Stage 02: Industry Consultation

Grid Code

GC0076 Grid Code Limits On Rapid Voltage Changes

Figure CC6.1.7 - Time and magnitude limits for a Category 3 Rapid Voltage Change

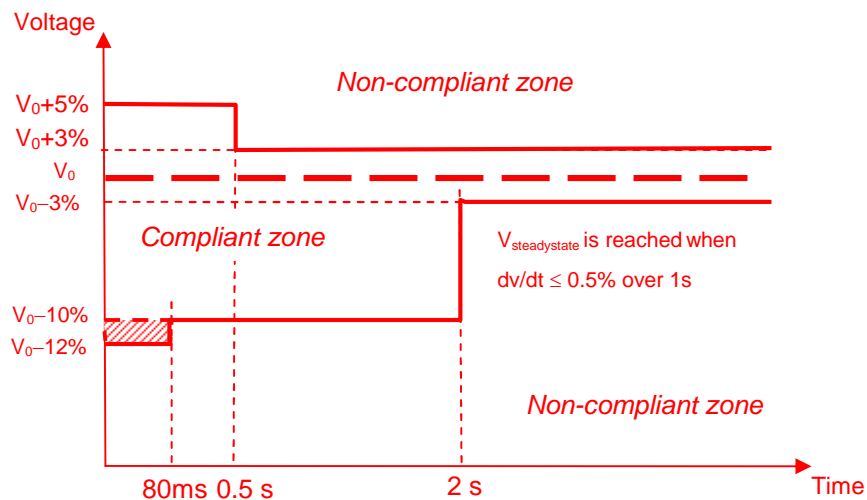
<p><i>In proposed Figure CC6.1.7:</i></p> <ul style="list-style-type: none"> <i>• the reason for a proposed $V_0+5\%$ for 0.5s compliant zone is not discussed in the consultation document. What is National Grid’s reasoning for this?</i> <i>• the relevance of the statement “$V_{steadystate}$ when $dv/dt \leq 0.5\%$ over 1s” to the diagram is not clear.</i> <i>• The relationship of the unnamed vertical axis with $\% \Delta V_{steadystate}$ and $\% \Delta V_{max}$ is not clear</i> <i>• I assume that the unnamed horizontal axis represents time between voltage disturbances</i>

<ul style="list-style-type: none">• <i>The time parameters which were proposed in consultation document figure 2 have been omitted from Figure CC6.1.7</i>• <i>Table CC.6.1.7 category 3 says $\% \Delta V_{max}$ up to 12% may be acceptable but Figure CC6.1.7 only allows negative rapid voltage changes of this magnitude (while allowing positive and negative rapid voltage changes of 3%). What is the reason for this?</i>
--	--
